Overview: Production error in version 1.0 harnesses; The immobilizer wire (orange/black) is in pin position #4 instead of pin position #5. Although an effort to correct the issue was made, some quantity of harnesses did get shipped before the issue was spotted. We are advising to inspect the harness BLADE connector before attempting to install harness or program the module. This issue is not known to affect the version 2 harnesses, which require no modification.

Overview: Early versions of the FTI-STP1 harness require modification for **automatic transmission (AT)** applications, some of the product was able to be modified before release, but a small quantity was released without modification.

MODIFICATION REQUIRED FOR A/T APPLICATIONS, ONLY WITH v 1.0 HARNESS

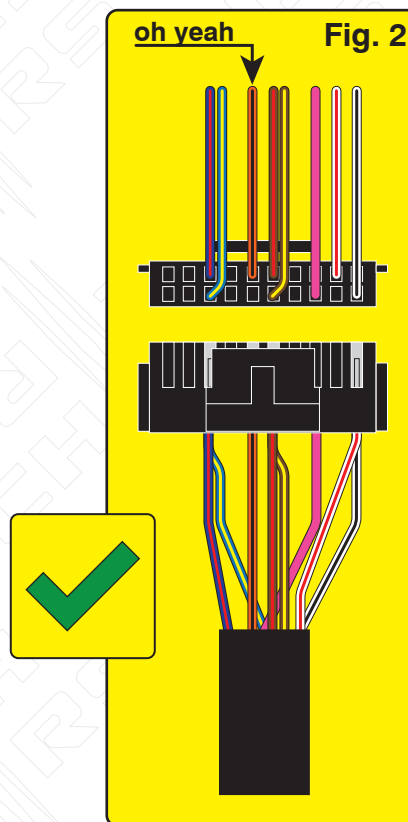
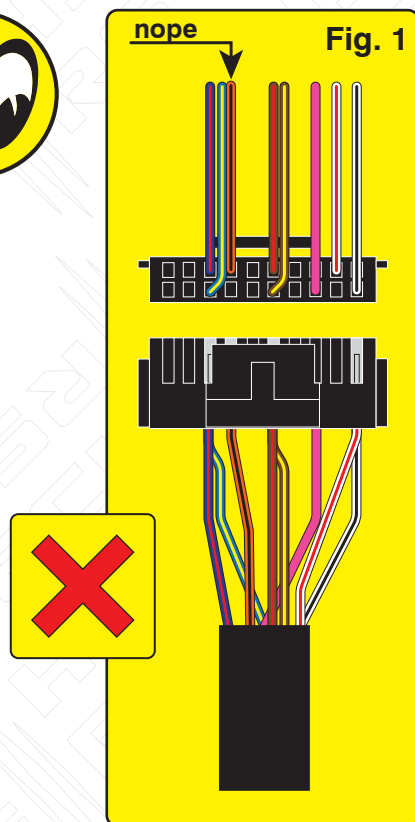
Issue: Module fails to program correctly to vehicle, does not allow the vehicle to be remote started.

Correction: Step 1.) Locate the orange/black wire and confirm whether it is positioned as illustrated in Fig. 1 or Fig. 2. If the wire is as illustrated in Fig.1, proceed with Step 2 through 5 and complete the repair procedure outlined, if the wire is as illustrated in Fig. 2, correction is not necessary, proceed with harness installation and module programming.

Step 2.) Using a pick, lightly depress the catch that secures the terminal in the housing then remove the wire and terminal from the housing.

Step 3.) Using a fine tip razor or utility knife, insert the blade beneath the terminal catch and raise it slightly, so that it can be reused to secure the terminal when reinserted into the BLADE connector housing.

Step 4.) Refer to Fig. 2 for correct position of the orange/black wire (next to brown/red) then reinsert the terminal, pressing lightly until the catch 'snaps' into place, securing the terminal in the connector housing.

Step 5.) The repair is complete, proceed with installation and programming.

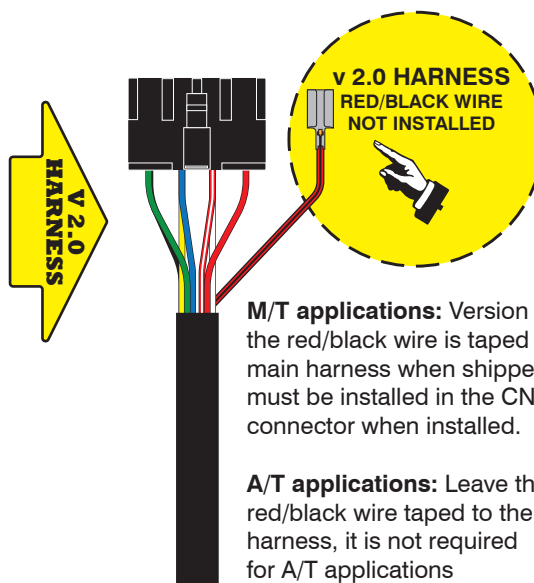
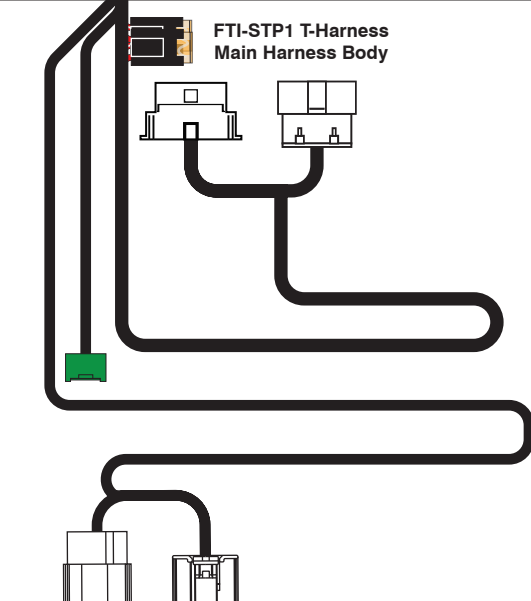
Issue: The FTI-STP1 T-harness has been designed to be compatible with A/T (automatic transmission) & M/T (manual transmission) applications, but due to an oversight in early production runs, the selection was defaulted to M/T mode.

Using a harness configured for an M/T application, in an A/T equipped vehicle, could result in vehicle module damage, it is advised that the harness be returned to A/T mode before installation in vehicles equipped with an automatic transmission.

Correction: Locate the **red/black** (+ Clutch) wire provided in the CN1 connector of the main harness assembly. Cut the **red/black** wire, either flush to the CN1 connector, or leaving enough wire exposed so that you can insulate and secure the ends of the wire that remain after cutting. Insulate each of the remaining ends of the **red/black** wire and secure to prevent any possibility of a short circuit. **If the red/black wire has already been disconnected, no further modification is required for A/T applications**

MODIFICATION NOT REQUIRED WHEN USING FTI-STP1 (v 1.0) HARNESS IN M/T APPLICATIONS, OR WHEN USING THE FTI-STP1 (v 2.0) HARNESS
